## CDRC DRB – 2/28 Review Response

Project: Tucson Convention Center  
Lot A Garage  
260 S Church Ave

**TCC Lot A Garage**  
**Revised Northeast Pedestrian Crossing**  
**03-06-2020**

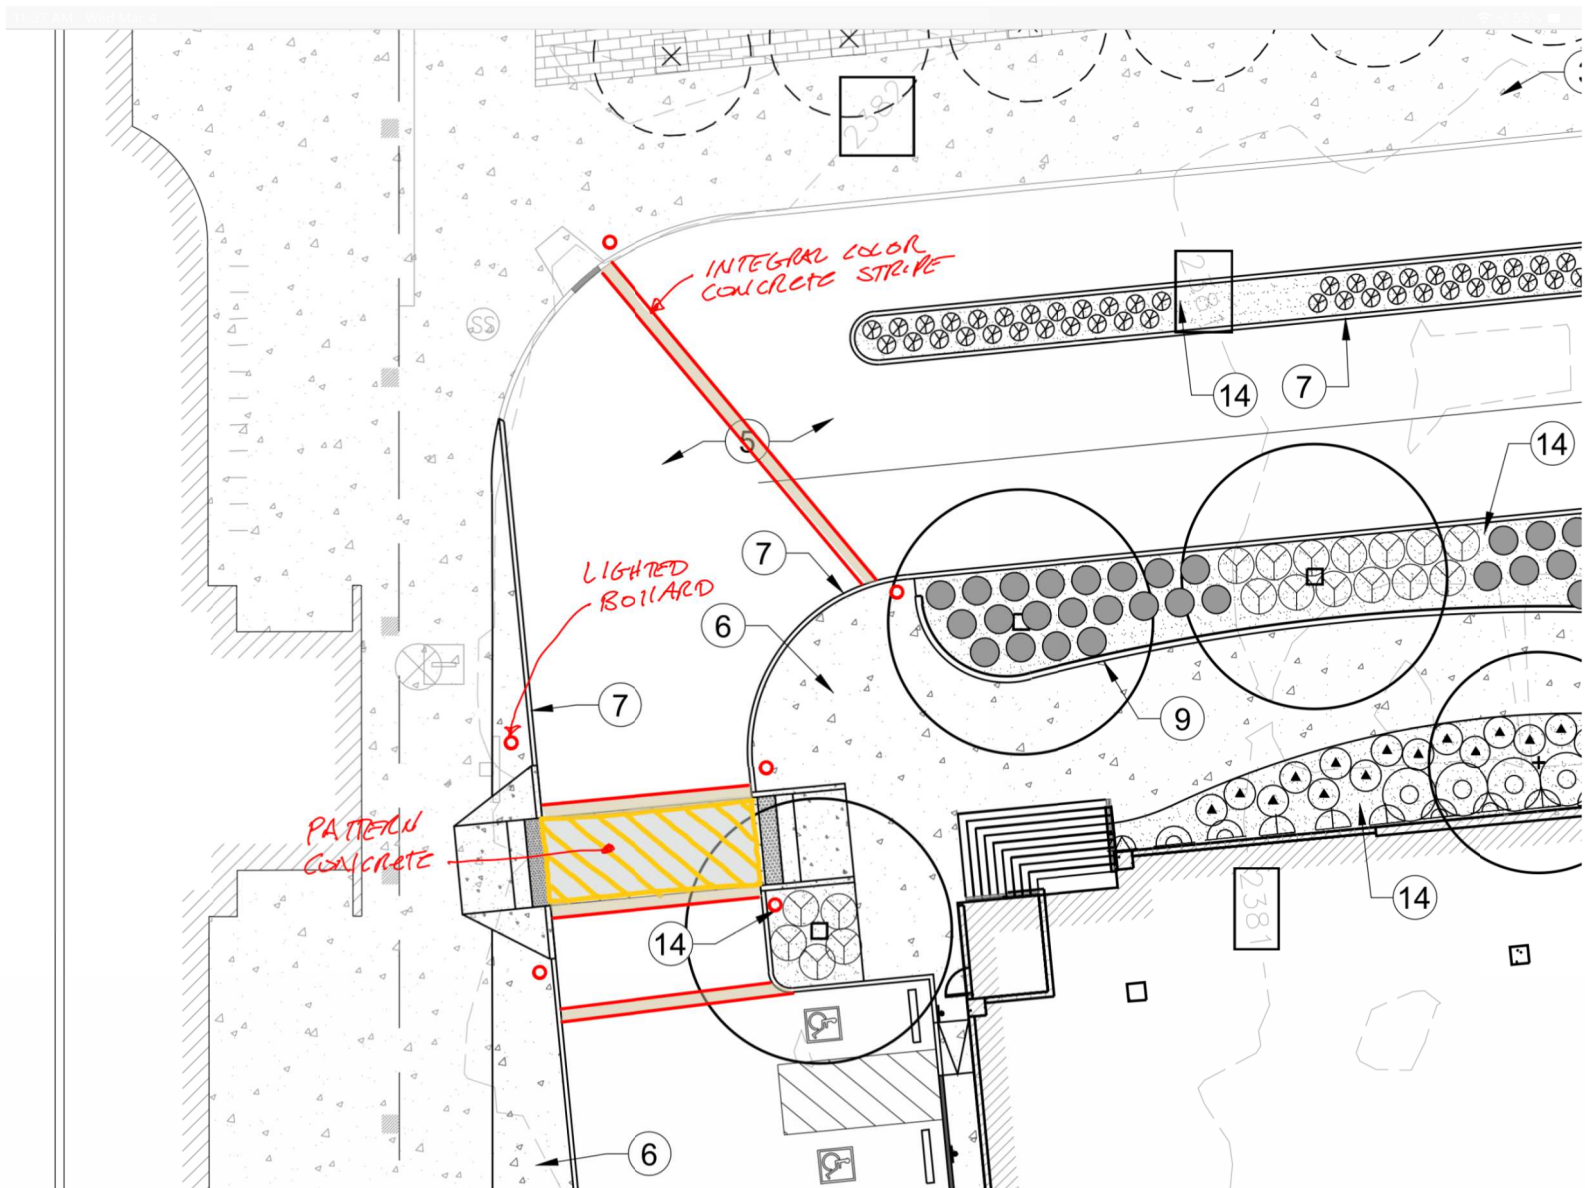
5.12.7-C-10. Safe and adequate vehicular parking areas designed to minimize conflicts with pedestrians and bicycles shall be provided.

Revised Response – The three primary pedestrian crossings have been revised to create contrast and pedestrian scale details to clearly define the crossings and create traffic calming in those areas. Patterned concrete will be used at the crossing to create a clear contrast in both color and texture to the adjacent asphalt PAAL. Lighted bollards will be added at the crossings to further define the crossings for both pedestrians and vehicles.
